07E-009

Re: NHTSA Campaign #07E-009
Components: SUSPENSION
Initiating Party: LKI Enterprises, Inc. dba Superlift Suspension™

SAFETY RECALL NOTICE

RE: Recall (LKI# 07-01): SUPERLIFT® Customer Notification and Instructions for replacement / reimbursement

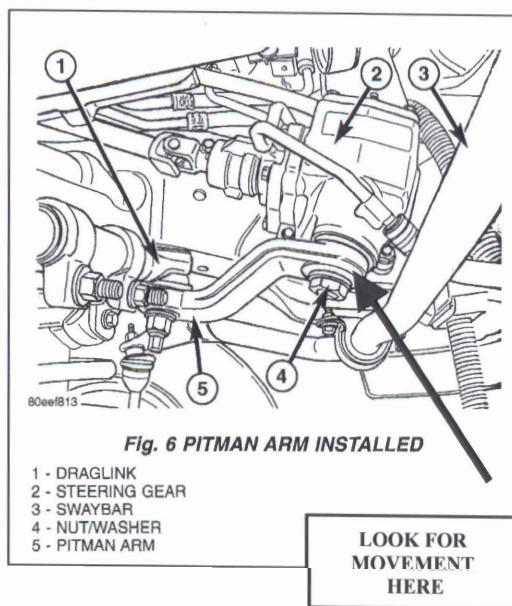
SAMPLE KIT BOX LABEL: Referencing the packaged date may help identifying suspect parts. Affected pitman arms were packaged between approximately 9/21/05 and 1/16/07. Superlift® packaged date begins with the 5th digit of the label. For example, this pitman arm was shipped 12/14/06. Additionally, pitman arms are identified by a paint stripe. Affected arms have a purple stripe; new edition arms have a gold stripe.
